### **TURKEY POINT NUCLEAR GENERATING STATION UNIT 3 AND UNIT 4**

#### **IMPROVED TECHNICAL SPECIFICATIONS CONVERSION**

##### **ITS SECTION 3.5 EMERGENCY CORE COOLING SYSTEMS (ECCS)**

**Revision 0**

Figure 3.5.5-1 (page 1 of 1)  
Seal Injection Flow Limits

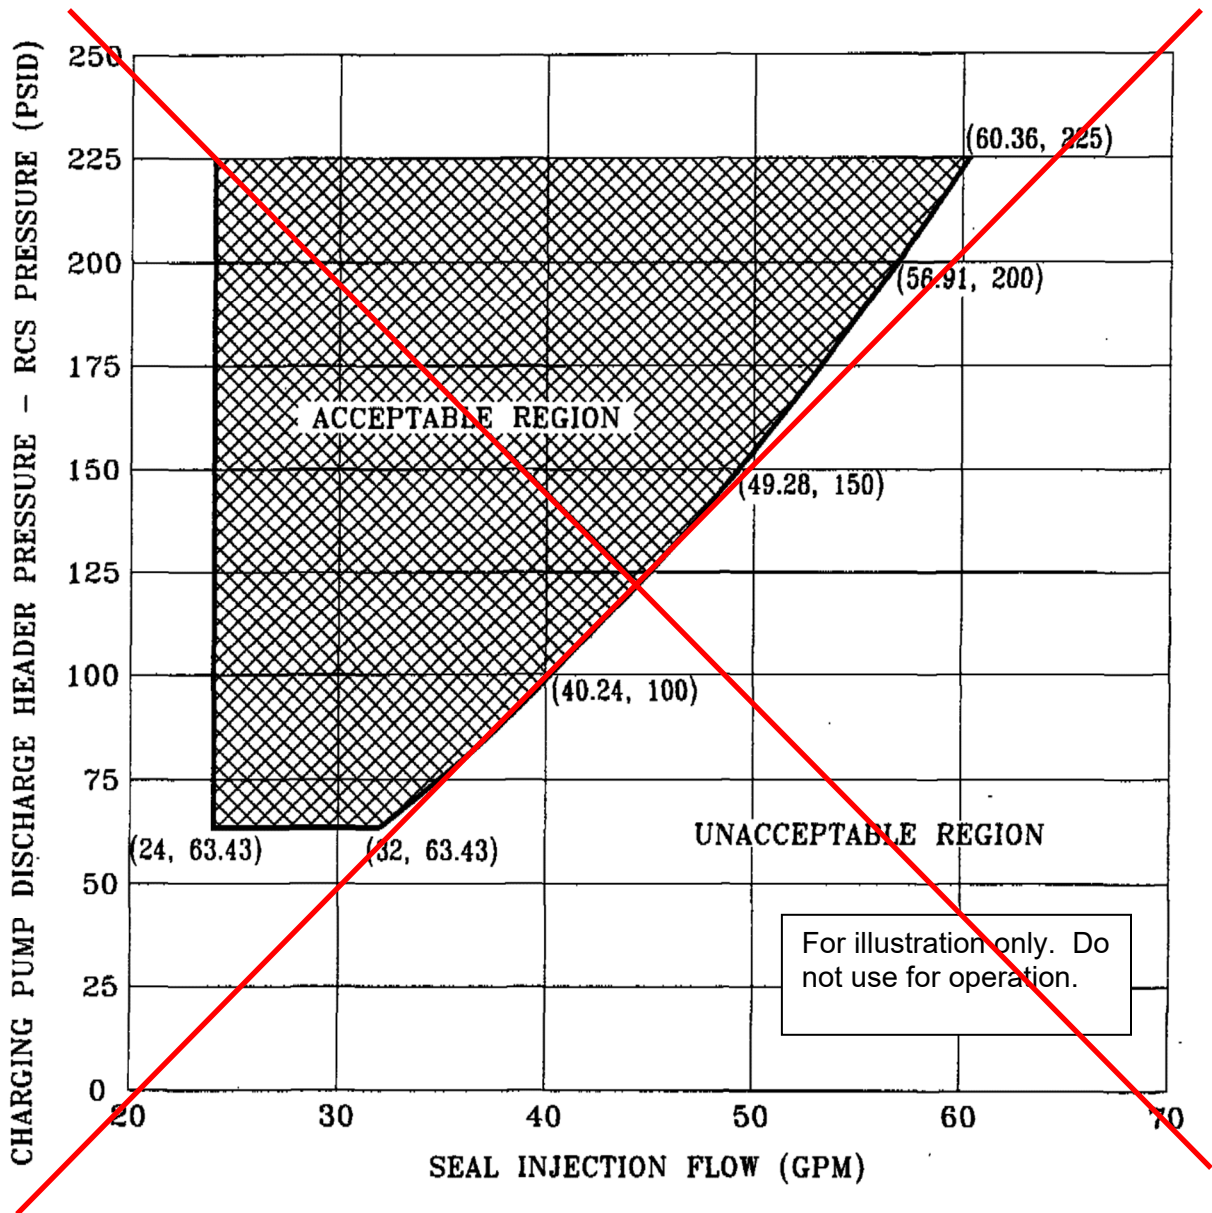
**JUSTIFICATION FOR DEVIATIONS  
ISTS 3.5.5, SEAL INJECTION FLOW**
